HumeLink

Amendment Report

Rev 0

May 2024

FIGURE 3-4f: Changes to construction compounds

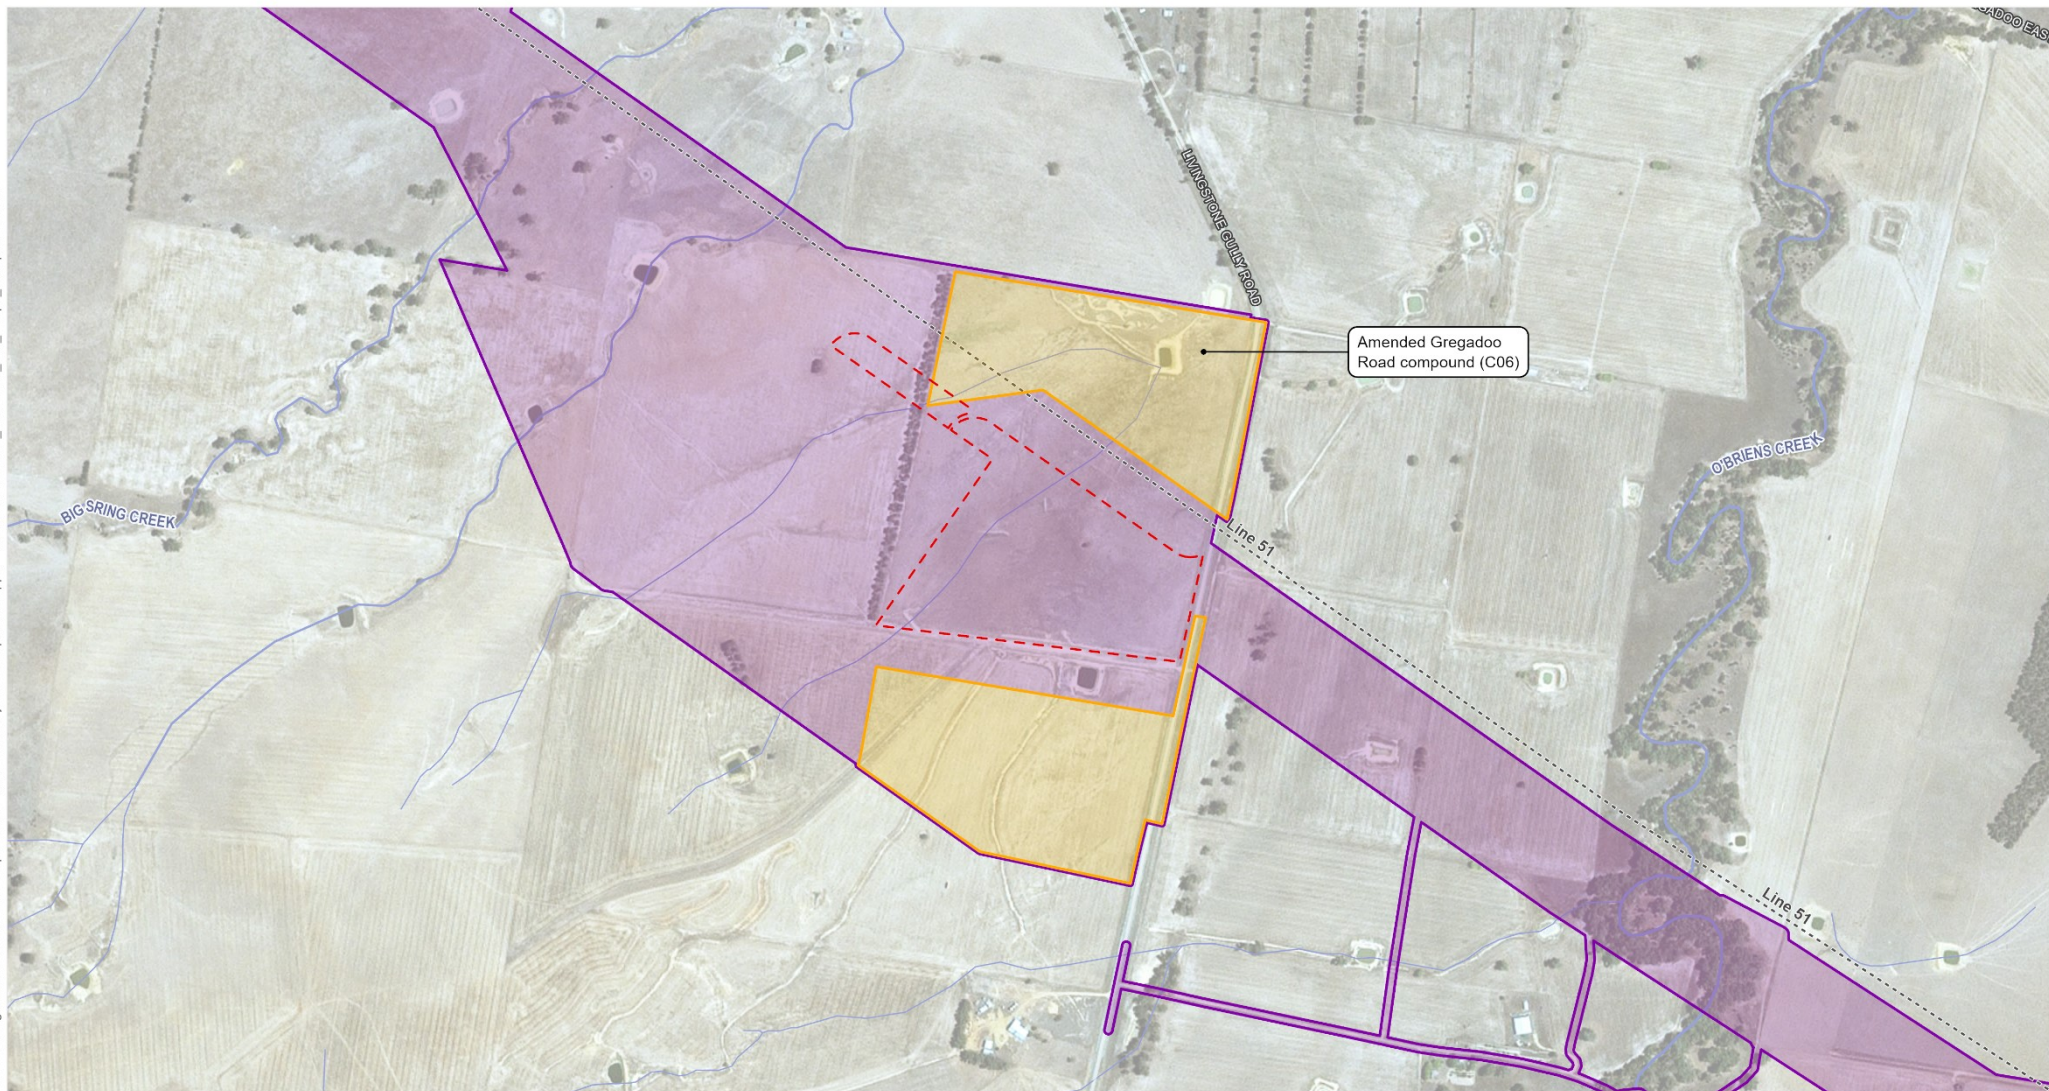
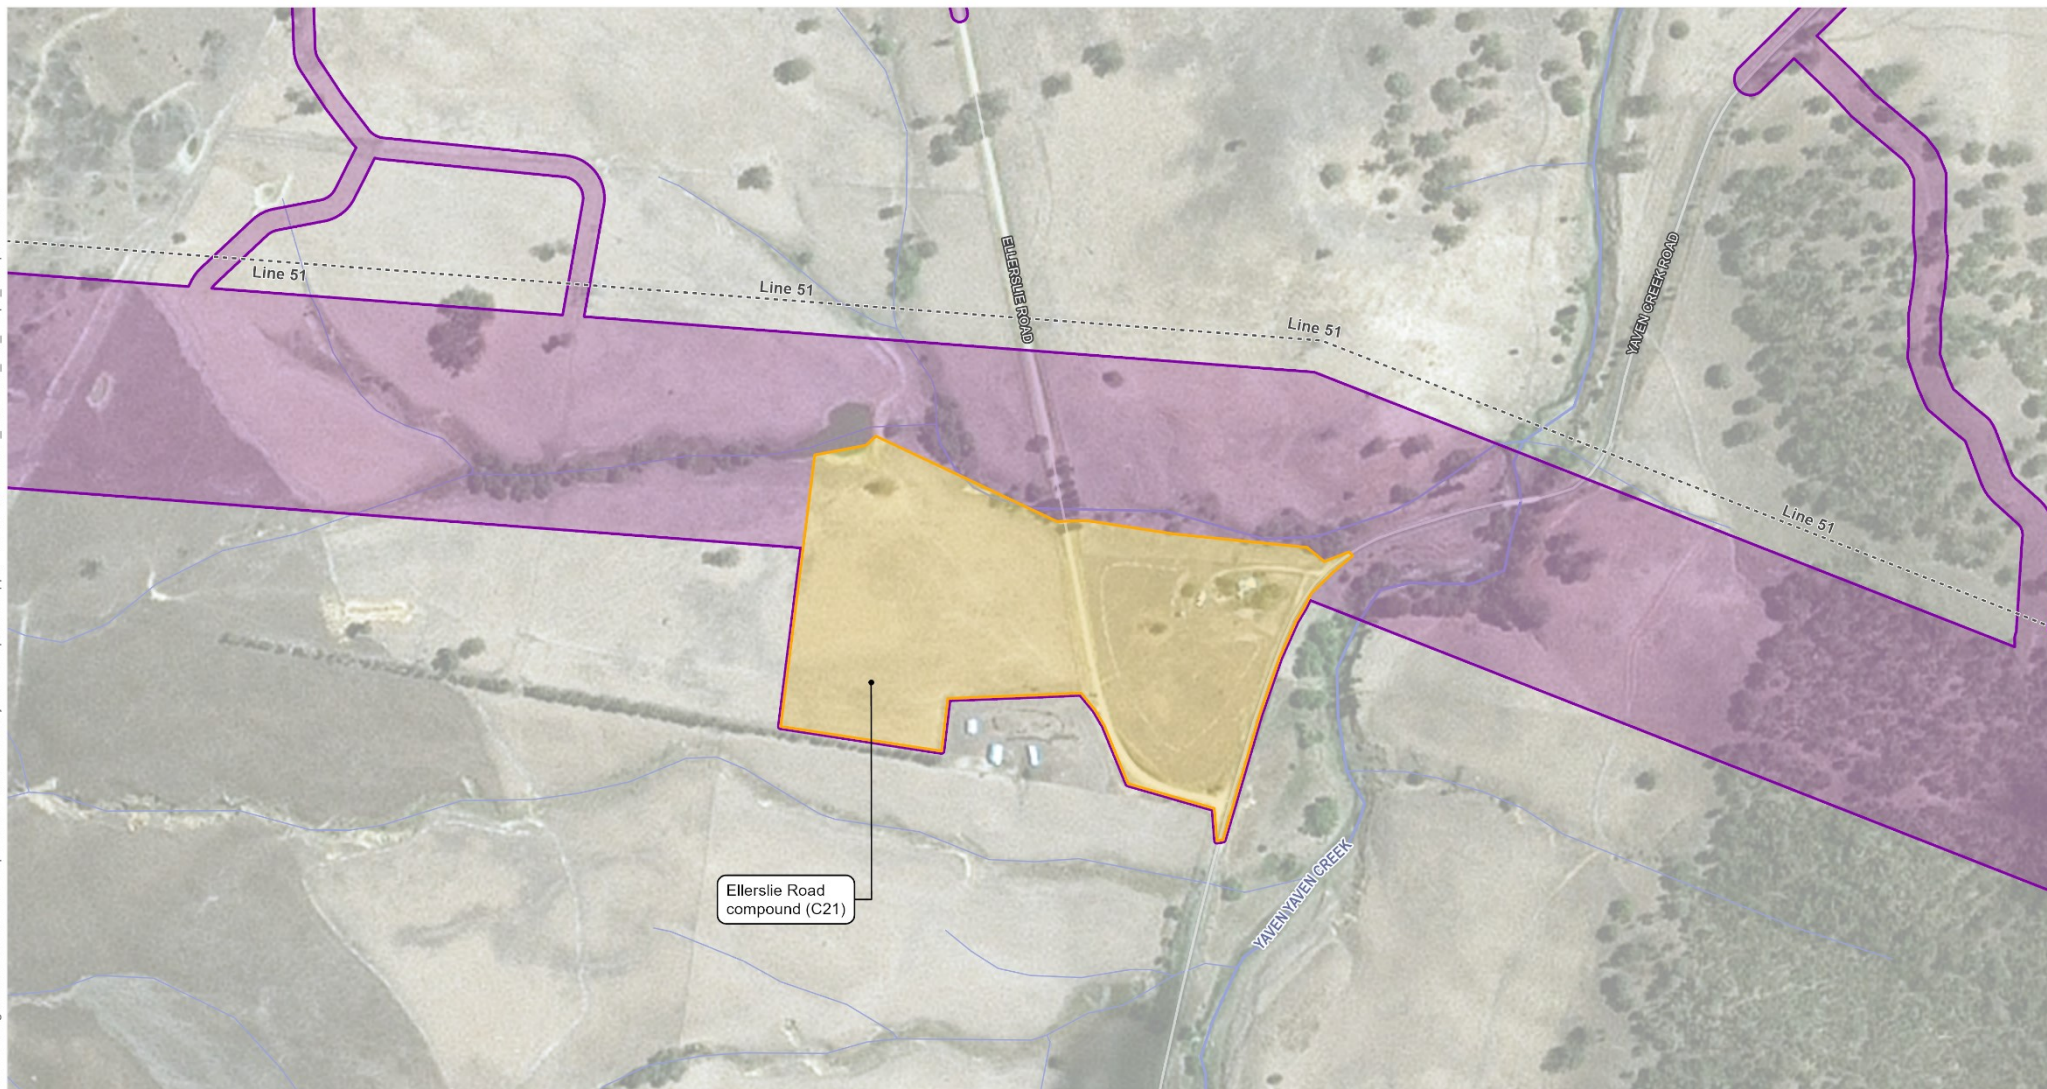
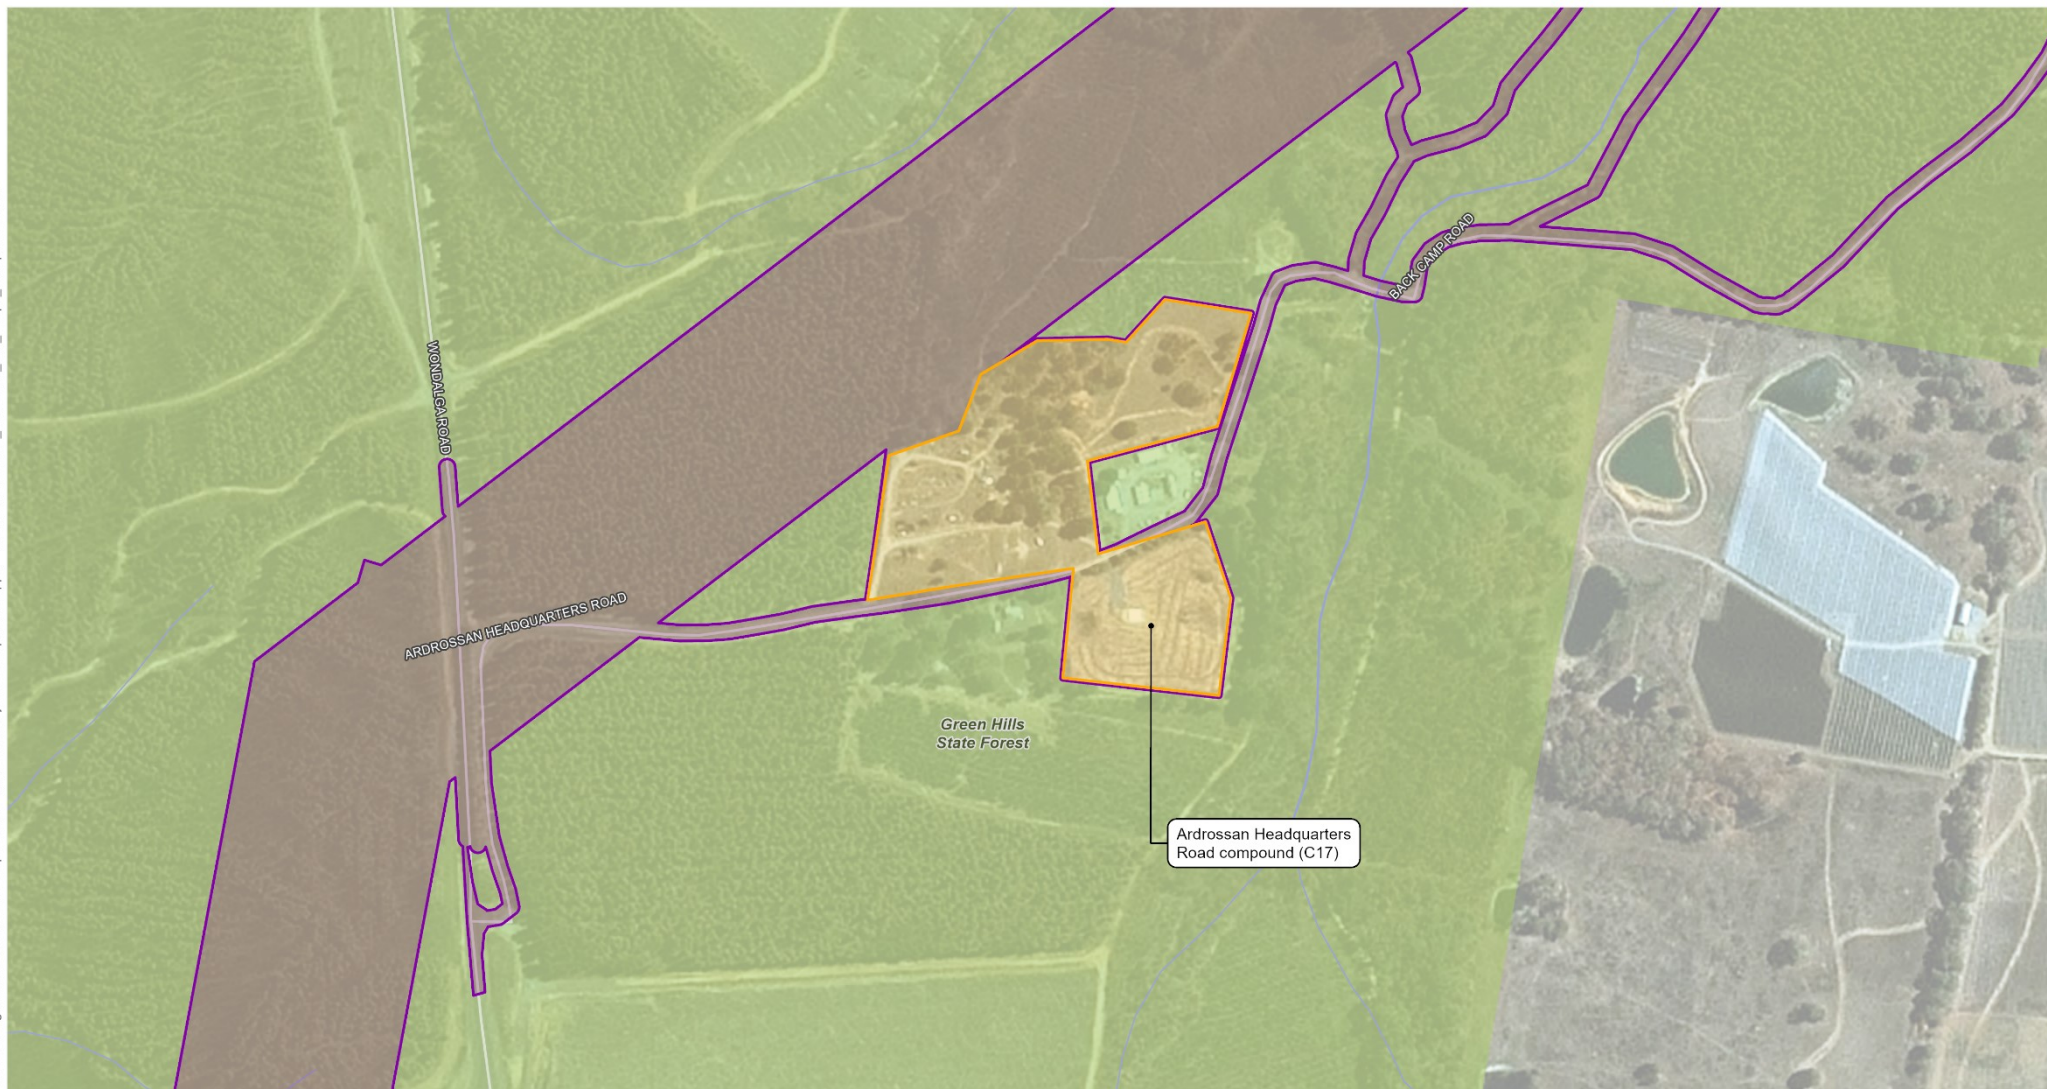
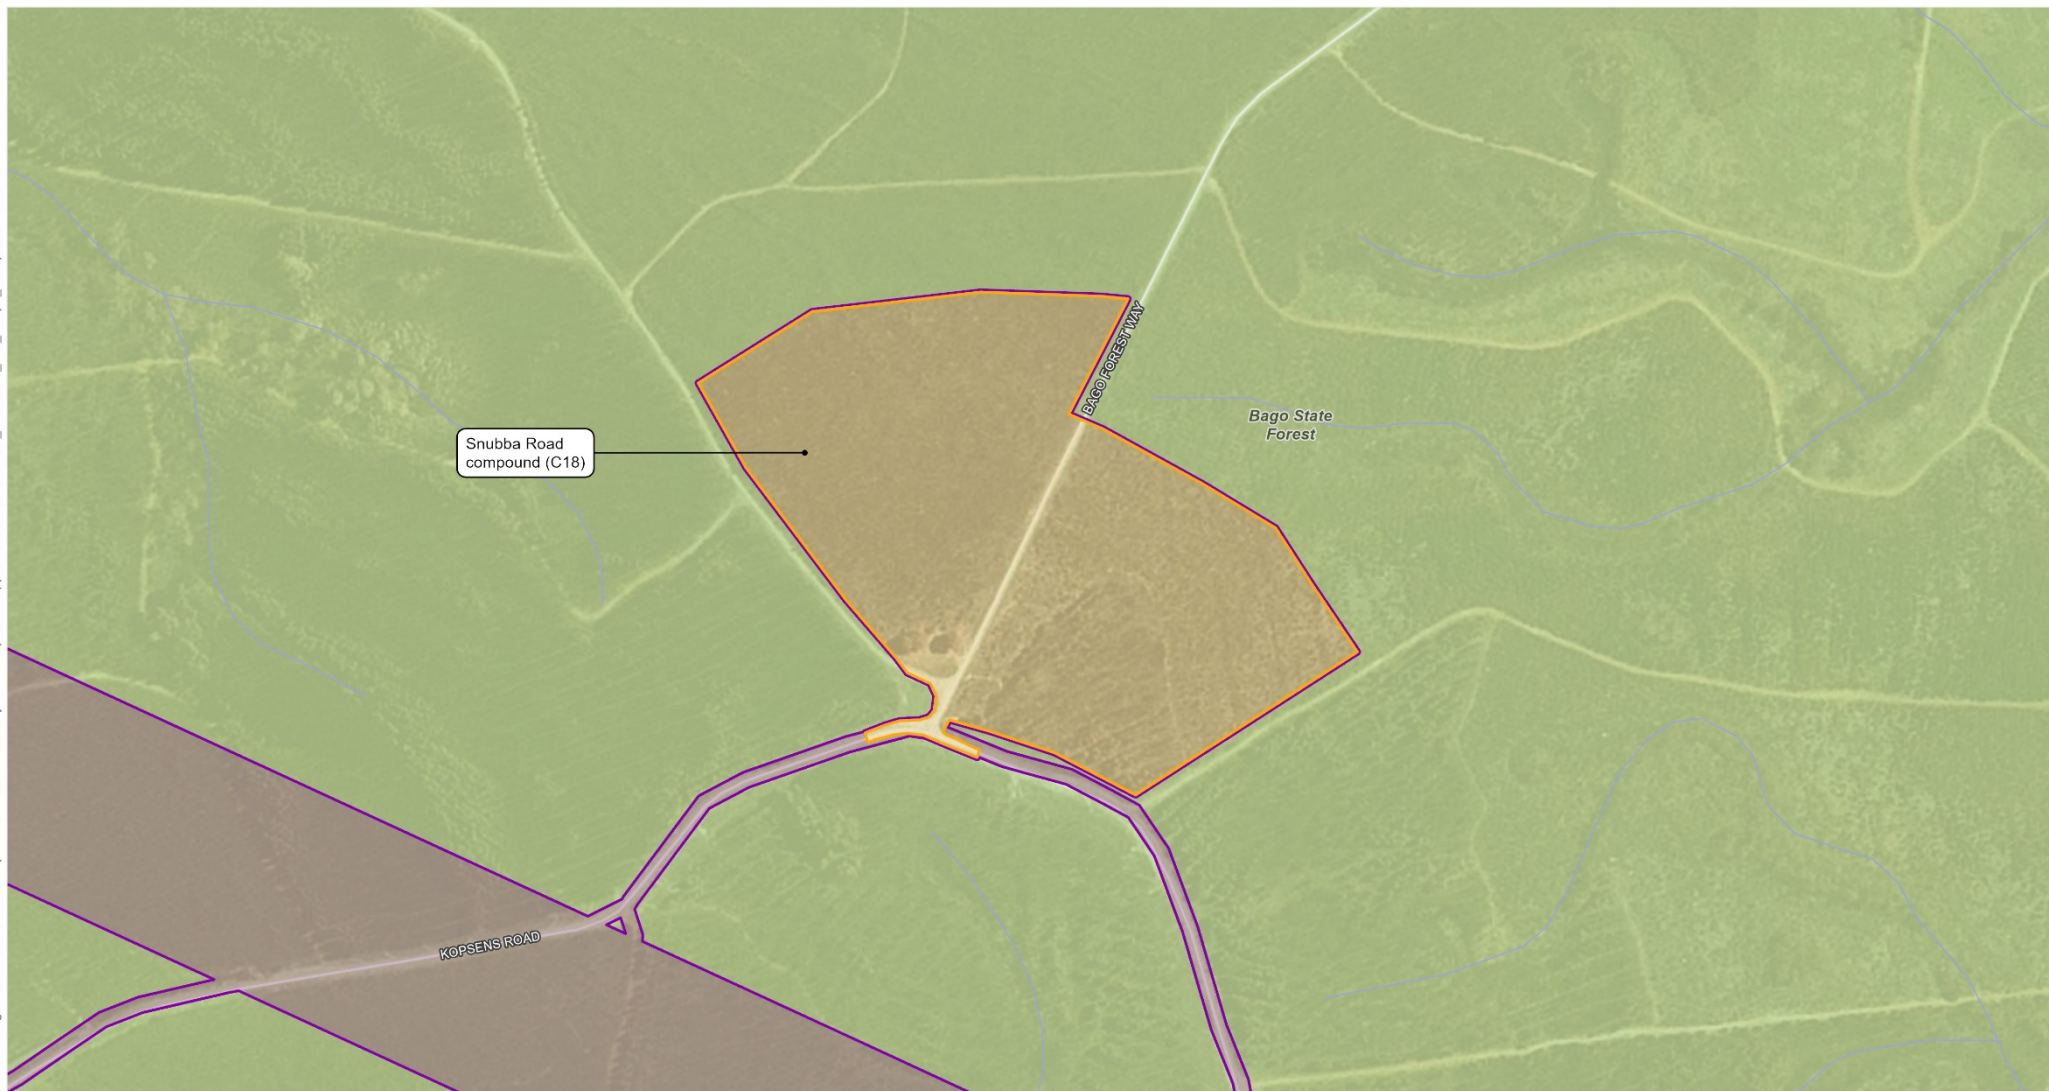
Table 3-4 provides a consolidated list and description of the standalone construction compounds. Further detail is provided in Appendix A (Updated project description). Figure 3-4 shows the locations of the changed standalone construction compounds.
